17 July 2018

**Subject: Amendment #2  
Interim Remedial Measures #2 Work Plan  
Former Sperry Remington Site #c808022  
Elmira, Chemung County**

<b>Observed Obstructions and Sheet Pile Progress</b>	
Former Sperry Remington Site North Portion IRM#2 Elmira, New York	
 <i>an affiliate of Geosyntec Consultants</i>	
Columbia, Maryland	July 2018
<b>Figure 1</b>

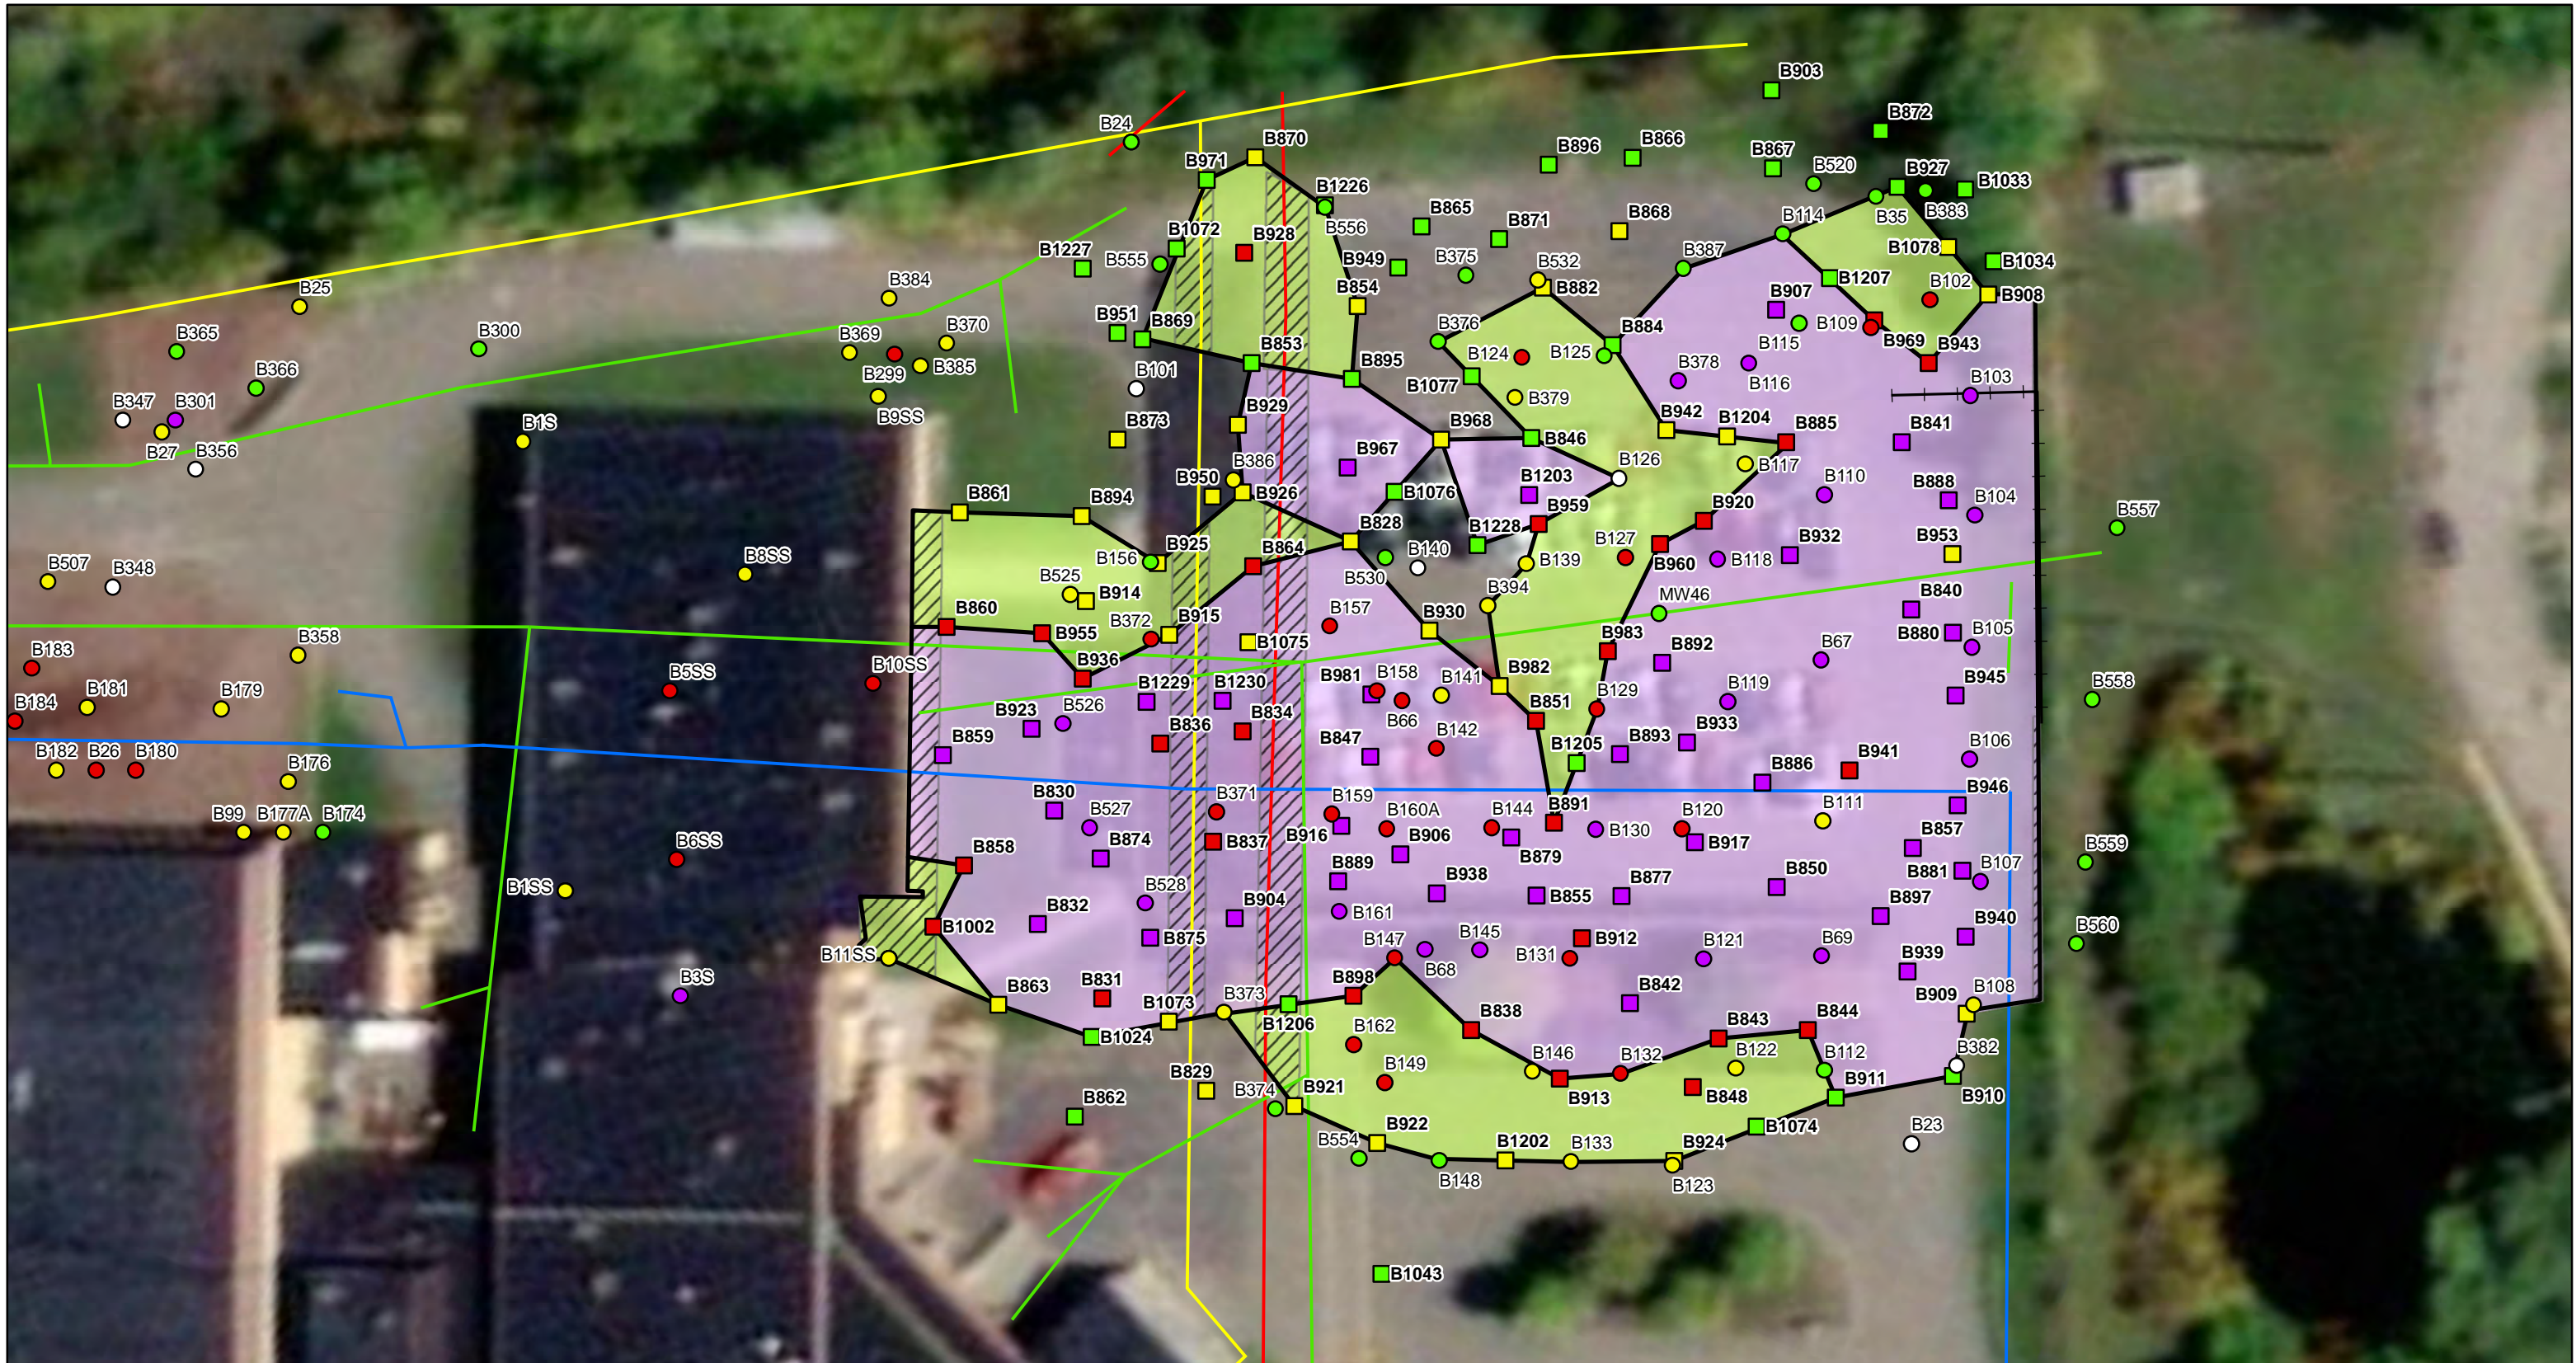
Temporary support of excavation (SOE) and benching will be required for areas of the Site with excavation depths of four (4) feet or greater. For the excavation area located along the south side of the K-Wing of the EHS building and the southern property boundary, steel sheet piles were proposed to provide SOE for excavation depths of approximately ten (10) feet below ground surface (ft bgs) and to support subsurface natural gas and electric lines at the boundaries of Phases 1 and 2 of the excavation. Steel sheet pile wall installation began on 23 June 2018 along the southern property boundary to establish the TSCA Accumulation Area. Concrete piers were observed in the trench excavated for sheet pile installation. Sheet pile installation progress was slower than anticipated due subsurface obstructions. Sheet piles installed on the western end of the southern sheet pile wall have bowed out. To date, sheet pile wall has been installed for a length of approximately 84 feet on the southern property line and a length of approximately 37 feet to form the eastern wall of the TSCA Accumulation Areas as shown on **Figure 1**. The latter is not being used to provide temporary SOE. On 29 June 2018, Geosyntec requested to modify the sequence for sheet pile wall installation and relocate the crane for sheet pile installation to the EHS building in order to meet the schedule for Phase 1 excavation and backfill. NYSDEC provided email approval and the modification has been documented in Amendment #1 to IRM #2 Work Plan dated 3 July 2018. Concrete blocks covered with poly sheeting were placed at the northern boundary of the TSCA Accumulation Area and a second line of silt fence was installed south of the property boundary. Sheet pile installation for the Phase 1 excavation began on 30 June 2018. Sheet pile refusal was encountered at multiple locations south of the EHS building, north of the gas line and at the western edge of the milled asphalt as shown on **Figure 1**. Geosyntec has determined that further sheet pile installation is not feasible for the IRM #2 construction schedule due to subsurface obstructions. Revised Construction Drawings are included as **Attachment 1**.
